UNITED STATES PATENT AND TRADEMARK OFFICE

APPLICATION NO.	FILING DATE	FIRST NAMED INVENTOR	ATTORNEY DOCKET NO.	CONFIRMATION NO.
10/701,557	11/06/2003	Hiroshi Yamamoto	8038-1049	9561
466	7590	05/06/2005		EXAMINER NGUYEN, HIEP
YOUNG & THOMPSON 745 SOUTH 23RD STREET 2ND FLOOR ARLINGTON, VA 22202			ART UNIT 2816	PAPER NUMBER

DETAILED ACTION

Claims 3-8 are rejected under 35 U.S.C. 103(a) as being unpatentable over Elassaad et al. (US 2004/0257207A1) in view of Porterfield (US Pat. 6,588,001) and Ozawa (US Pat. 4,626,712).

Fig. 3Fig. 4

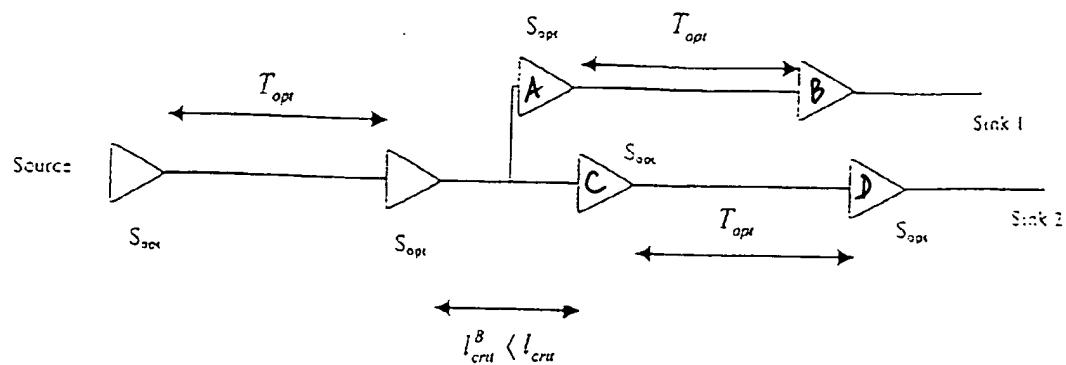
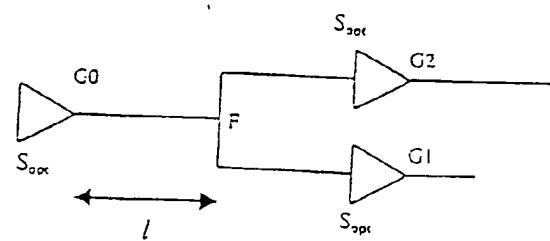
Regarding claim 3, figure 3 of Elassaad shows a semiconductor device comprising: a plurality of repeaters (Sopt), inserted in the transmission line to divide the signal transmission line into a plurality of divided signal lines. Figure 3 of Elassaad does not show that each repeater comprises two inverters and the first inverter is larger than the second inverter. However, it is old and well known to an artisan having skilled in the art that a buffer comprises two inverters and it can be used as repeater (see Porterfield, US Pat. 6,588,001; Fig. 2; col. 1, lines 55-67). Figure 2 of Porterfield does not show that the first inverter (220) is larger than the second inverter (215). Figure 6 of Ozawa shows a repeater circuit comprising two inverters where in, the first inverter (Q61, Q62) is larger than the second inverter (Q63, Q64) for providing a repeater that is not affected by the deviation of channel lengths caused by manufacturing process while the smaller inverter provides high speed (col. 5, lines 49-56). Therefore, it would have been obvious to an artisan having skills in the art to replace the repeater of Porterfield with the repeater taught by Ozawa for providing a repeater that is not affected by the deviation of channel lengths caused by manufacturing process while the smaller inverter provides high speed.

Regarding claims 5 and 6, the combination of Elassaad, Porterfield and Ozawa shows a branch comprising another repeater (B, see attached paper) that includes a repeater, taught by Ozawa, including two inverters; the first inverter having a current driveability larger than a current driveability of said second inverter. The input signal applied to the first inverter (A) is a clock signal.

Regarding claim 7, figures 3 and 6 of Elassaad show that the signal line has wire capacitance (Cw). The wire capacitance causes wire delay that is at least 7 times that of the driver (paragraph [0112]). Thus, the signal line has a higher capacitance than an input capacitance of the repeater.

Regarding claim 8, figures 3 and 6 of Elassaad show a semiconductor device comprising: first and second functional blocks, not shown, connected via a signal transmission line; plurality of repeaters (A,B) in the transmission line that divide the signal transmission line into plural divided signal lines, each of the divided signal lines having a higher capacitance than an input capacitance of a respective one of said repeaters connected thereto (paragraph [0112]). Figure 3 of Elassaad does not show that each repeater comprises two inverters and the first inverter is larger than the second inverter. However, it is old and well known to an artisan having skilled in the art that a buffer comprises two inverters and it can be used as repeater (see Porterfield, US Pat. 6,588,001; Fig. 2; col. 1, lines 55-67). Figure 2 of Porterfield does not show that the first inverter (220) is larger than the second inverter (215). Figure 6 of Ozawa shows a repeater circuit comprising two inverters where in, the first inverter (Q61, Q62) is larger than the second inverter (Q63, Q64) for providing a repeater that is not affected by the deviation of channel lengths caused by manufacturing process while the smaller inverter provides high speed (col. 5, lines 49-56). Therefore, it would have been obvious to an artisan having skills in the art to replace the repeater of Porterfield with the repeater taught by Ozawa for providing a repeater that is not affected by the deviation of channel lengths caused by manufacturing process while the smaller inverter provides high speed.
